**Before the  
FEDERAL COMMUNICATIONS COMMISSION  
Washington, D.C. 20554**

**SUPPLEMENT TO PETITION TO DENY OF VIASAT, INC.**

**SUPPLEMENT TO PETITION TO DENY OF VIASAT, INC.**

**Figure 1: Derivation of Geographic Skew Angle**

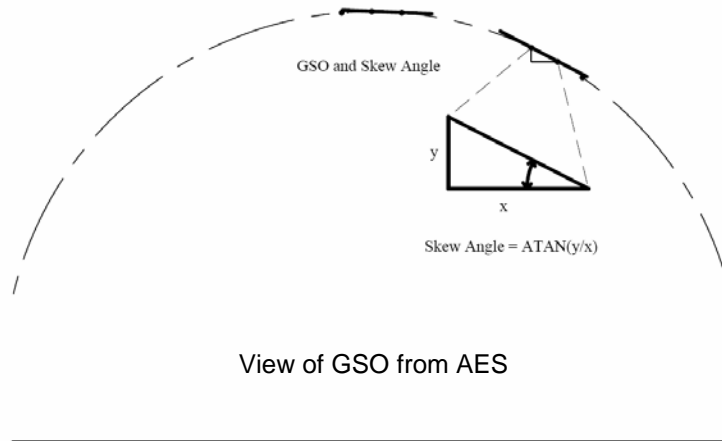
Even if  $65^\circ$  were the appropriate separation angle, Row 44 fails to account for the effects of aircraft banking in discussing its implementation of the proposed  $25^\circ$  limit. Figure 1 shows the derivation of the geographic skew angle based on the relative position of the "target" and "victim" satellite on the GSO arc:

While Row 44 acknowledges the importance of geographic skew, Row 44 does not discuss the effects that aircraft banking would have on the alignment of the azimuth and elevation axes of its antenna. In level flight, the elevation axis of the antenna would be vertical and perpendicular to the GSO arc when the aircraft is due North of the operating satellite. However, when the aircraft banks, the elevation antenna pattern would be tilted with respect to the GSO arc because the AeroSat antenna Row 44 proposes to use does not have a mechanism to adjust for this tilt. Depending on the direction of the bank, the tilt would either add to or subtract from geographic skew.

**Figure 2: Geographic Skew at Sioux Falls, SD**

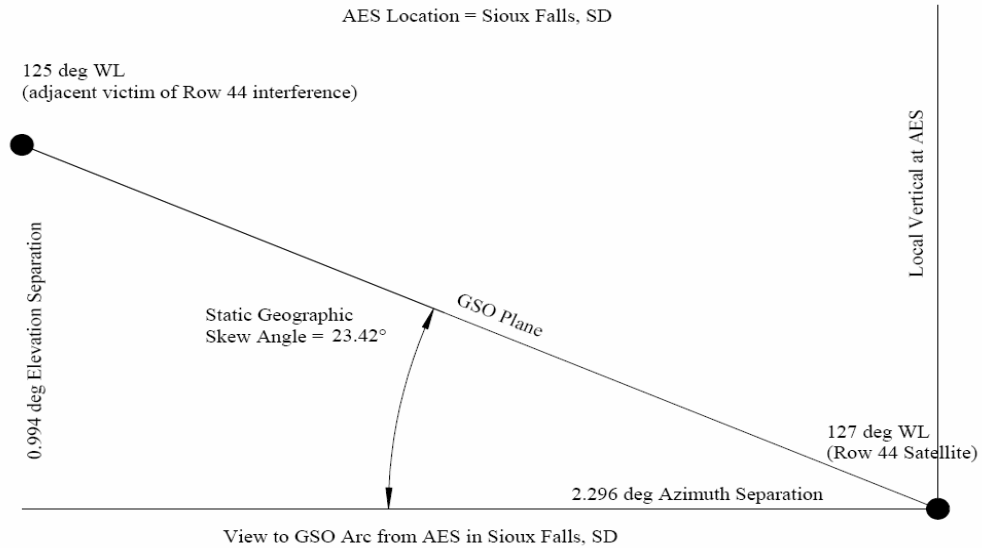
Figures 2 through 4 depict an AES located in the vicinity of Sioux Falls, South Dakota and pointed at the Horizons-1 satellite, located at 127° WL, which Row 44 plans to utilize. As shown in Figure 2, the relevant geographic skew angle from this location is 23.42° – barely less than the ± 25° limit specified by Row 44, without taking into account the effects of aircraft banking.

**Figure 3: Angular Separation from the GSO Arc During Level Flight at Sioux Falls, SD**

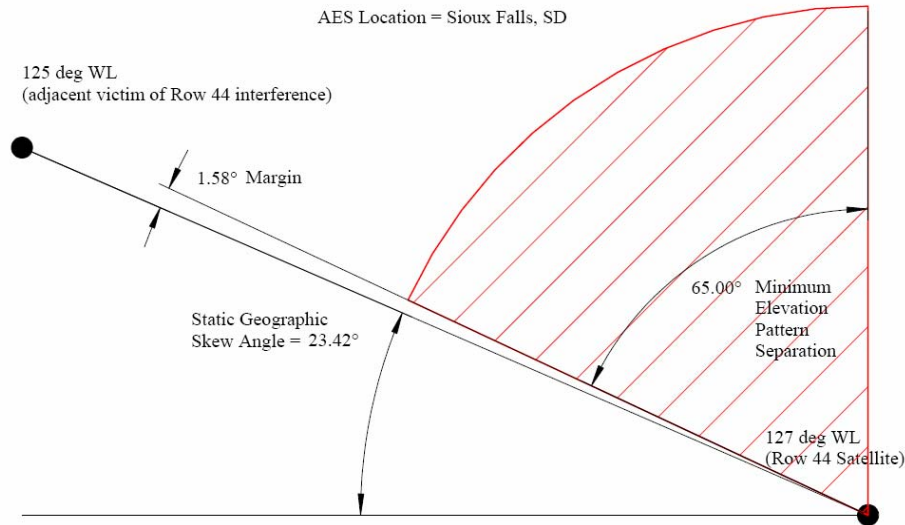
As shown in Figure 3, when the aircraft is level, the angular separation between the elevation antenna pattern from Row 44's proposed antenna and the GSO arc is approximately 66.58° – approximately 1.58° more than the 65° separation angle that Row 44 suggest would prevent harmful interference into adjacent satellites.

**Figure 4: Effects of 30° Bank on Angular Separation from the GSO Arc at Sioux Falls, SD**

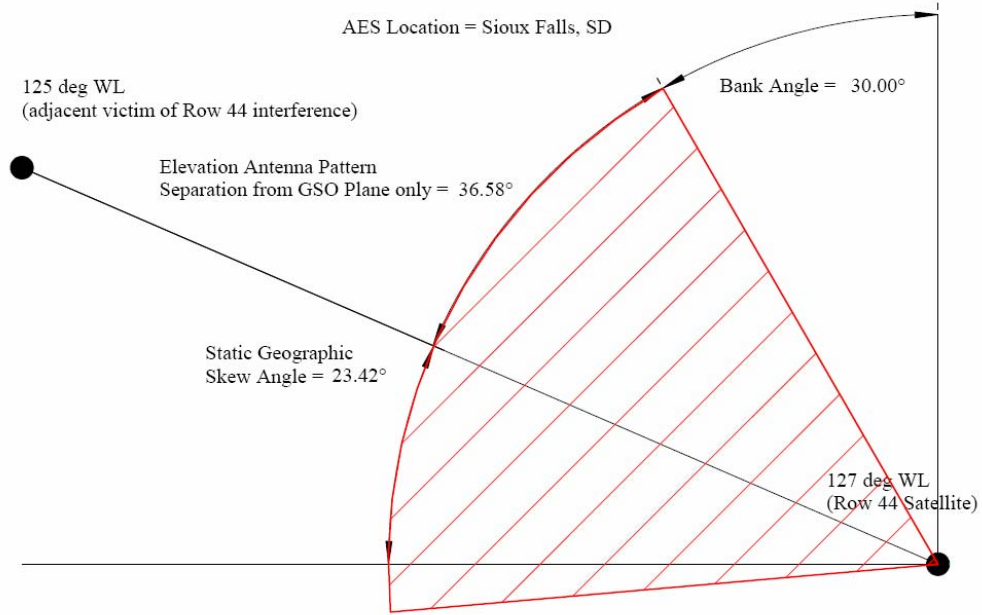
However, as shown in Figure 4, when an aircraft with a Row 44 terminal banks by more than 1.58°, it achieves an angular separation of less than 65°, and, therefore, presents an interference risk to adjacent spacecraft. When banking at 30°, the angular separation between the elevation antenna pattern from Row 44's proposed antenna and the GSO arc shrinks to approximately 36.58° – far less than the 65° separation angle that Row 44 suggests would be necessary to prevent harmful interference into adjacent satellites.

**Figure 5: Geographic Skew at Fairbanks, AK**

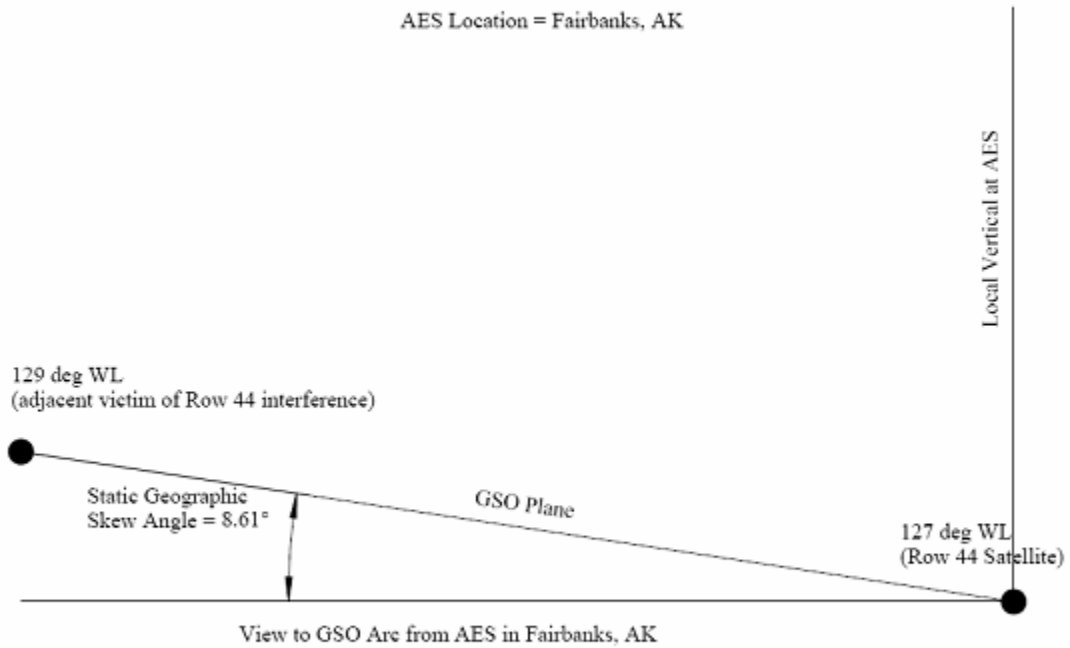
Banking can have a similar impact even where geographic skew is modest. Figures 5 through 7 depict an AES located in the vicinity of Fairbanks, Alaska and again pointed at the Horizons-1 satellite. As shown in Figure 5, the relevant geographic skew angle from this location is 8.61° – less than the  $\pm 25^\circ$  limit specified by Row 44.

**Figure 7: Effects of 30° Bank on Angular Separation from the GSO Arc at Fairbanks, AK**

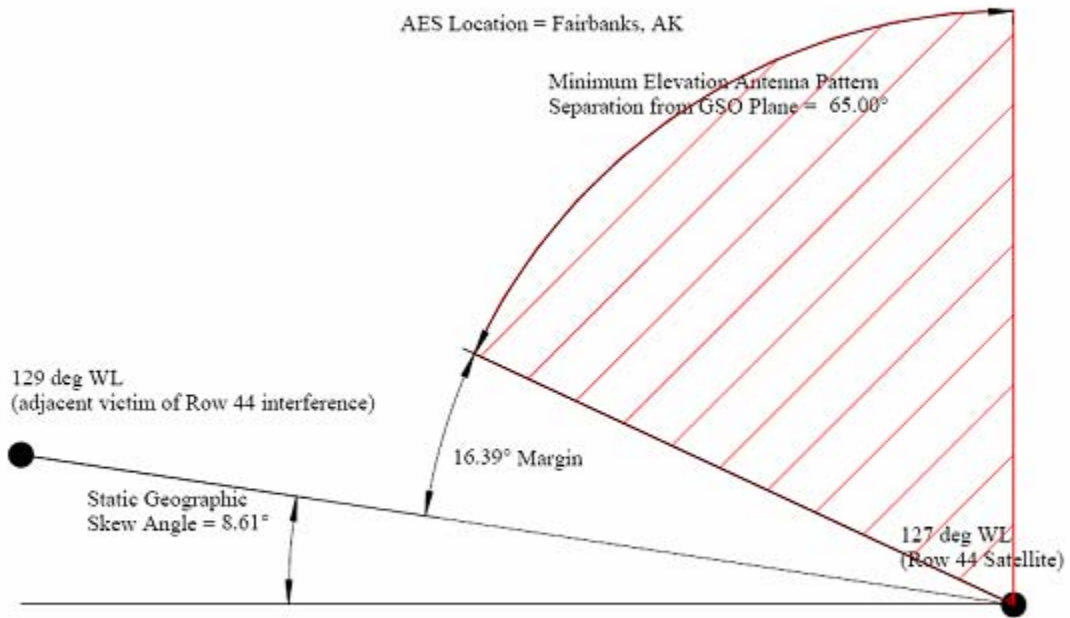
However, as shown in Figure 7, when the aircraft banks by 30°, the angular separation between the elevation antenna pattern from Row 44's proposed antenna and the GSO arc shrinks to approximately 51.39° – less than the 65° separation angle that Row 44 suggests would be necessary to prevent harmful interference into adjacent satellites. Here, any bank angle of greater than 16.39° would create an angular separation of less than 65°, and, therefore, pose an interference risk.

**Figure 6: Angular Separation from the GSO Arc During Level Flight at Fairbanks, AK**

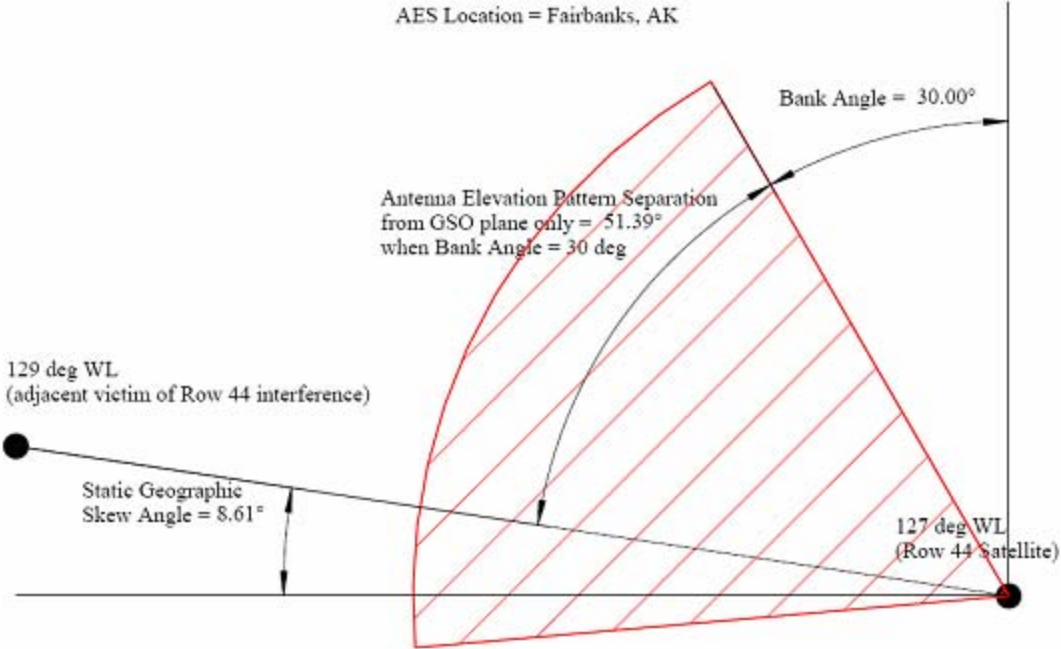
As shown in Figure 6, when the aircraft is level, the angular separation between the elevation antenna pattern from Row 44's antenna and the GSO arc is approximately  $81.39^\circ$  – thus, there is approximately  $16.39^\circ$  of margin from the  $65^\circ$  separation angle that Row 44 suggests would be necessary to prevent harmful interference into adjacent satellites.

**Figure 8: Geographic Skew at Colby, KS**

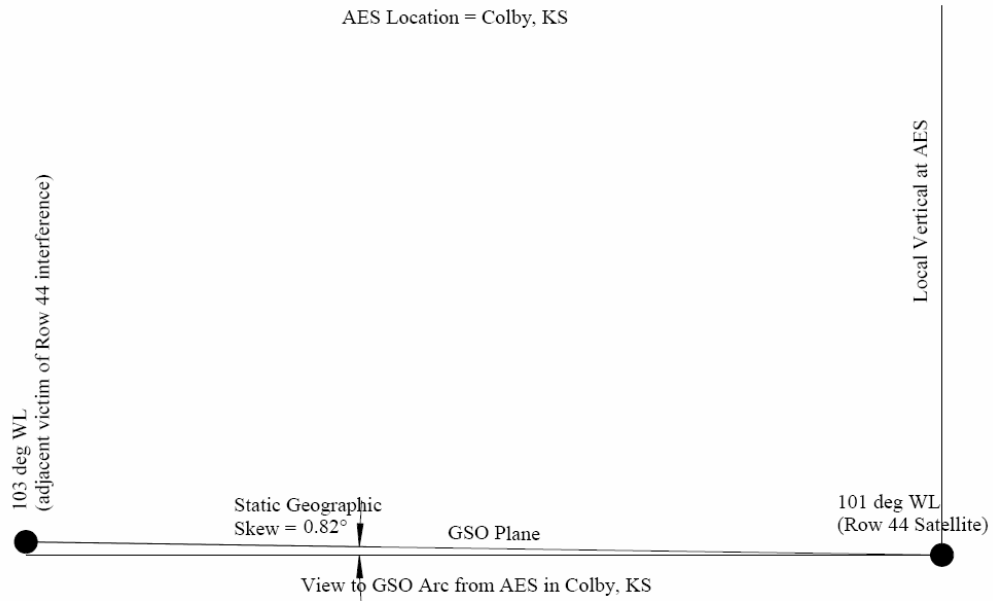
Banking also can have a similar impact where geographic skew is virtually non-existent. Figures 8 through 10 depict an AES located in the vicinity of Colby, Kansas and pointed at the AMC-2 satellite, located at 101° WL, which Row 44 also proposes to use. As shown in Figure 8, the relevant geographic skew angle from this location is 0.82° – practically negligible.

**Figure 9: Angular Separation from the GSO Arc During Level Flight at Colby, KS**

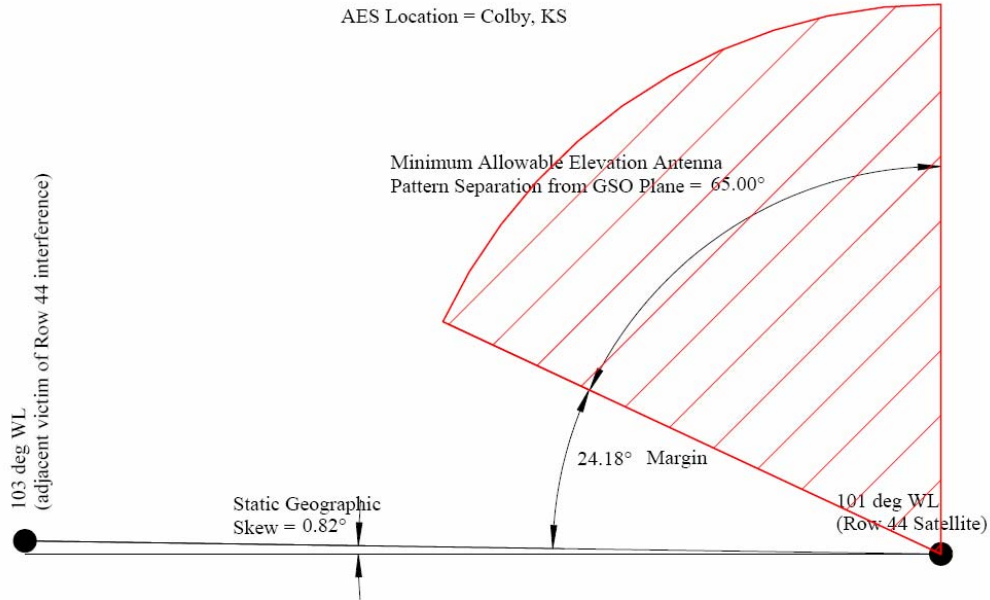
As shown in Figure 9, when the aircraft is level, the angular separation between the elevation antenna pattern from Row 44's proposed antenna and the GSO arc is approximately  $89.18^\circ$  – yielding approximately  $24.18^\circ$  of margin from the  $65^\circ$  separation angle that Row 44 suggests would be necessary to prevent harmful interference into adjacent satellites.

**Figure 10: Effects of 30° Bank on Angular Separation from the GSO Arc at Colby, KS**

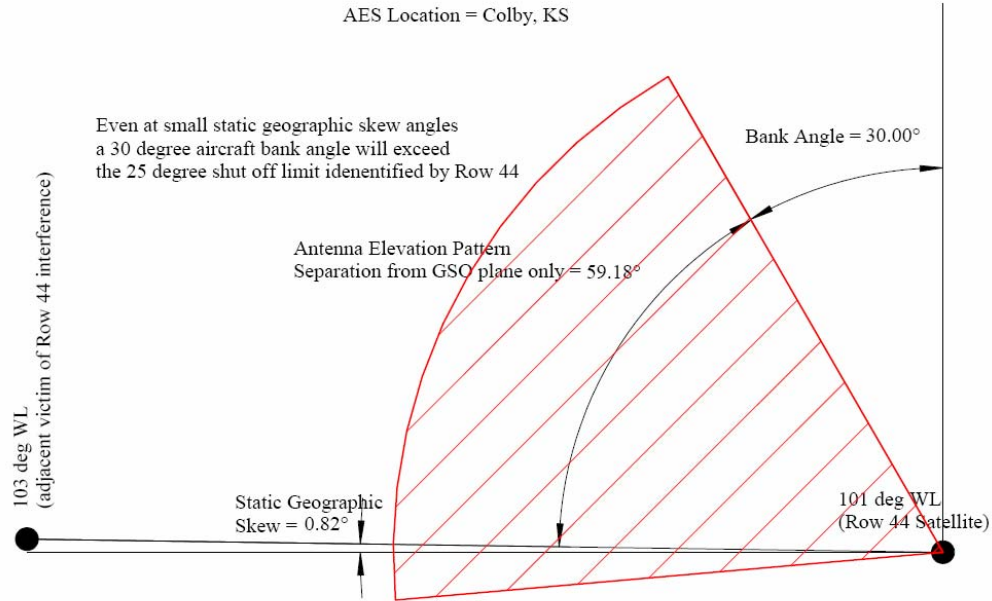
However, as shown in Figure 10, when the aircraft banks by 30°, the angular separation between the elevation antenna pattern from Row 44's proposed antenna and the GSO arc shrinks to approximately 59.18°, and therefore does not provide the 65° of separation that Row 44 suggests would be necessary to prevent harmful interference into adjacent satellites. In fact, any bank angle of greater than 24.18° would create an angular separation of less than 65°, and pose such a interference risk.

**Figure 11: Representative  $\pm 5^\circ$  Geographic Skew Angle Zones For Each of the Row 44 Satellites**

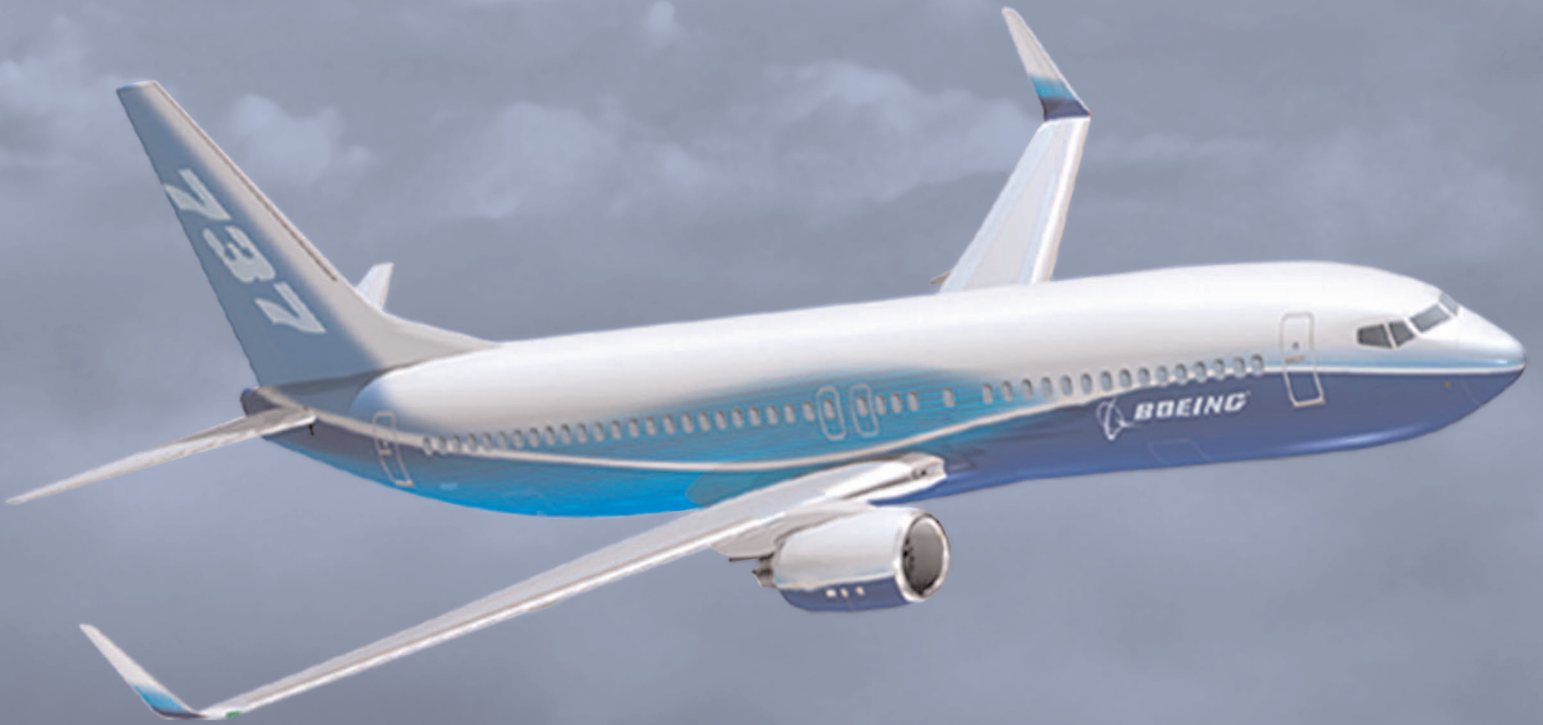
Further, Row 44 has not clearly depicted those areas in which it would not be able to provide service while banking. On many routes, Row 44 would be unable to provide service during even 5 degree banks – likely precluding any meaningful service during flight. Figure 11 is a Google Earth map depicting, approximately, the  $\pm 5^\circ$  geographic skew zones associated with each satellite with which Row 44 proposes to provide service. Within each zone (i.e., each pink area), an aircraft could bank from  $20^\circ$  (at the edges) to  $25^\circ$  (at the center) without exceeding a

combined  $\pm 25^\circ$  skew limit. However, outside of the zones, the allowable bank angle decreases to  $0^\circ$  when skew reaches  $25^\circ$ .

At a minimum, before it considers granting Row 44's application, the Commission should require Row 44 to provide a detailed explanation of (i) its derivation of  $\pm 25^\circ$  as the combined angular limit; (ii) the exact circumstances in which it would inhibit transmissions, accounting for both geographic skew and banking angle (and any other relevant factors); (iii) how it would determine if its antenna were misoriented by more than 25 degrees; (iv) how its system would inhibit transmissions if this threshold were exceeded; (v) how its system would manage skew, power levels, and other link parameters during hand-offs between satellites; (vi) the specific geographic areas in which Row 44 would not be able to offer service to the public during banks of 5, 10, 15, 20, 25, and 30 degrees; and (vii) the manner in which Row 44 plans to communicate its geographic service limitations to the airlines and the public in order to manage consumer expectations.
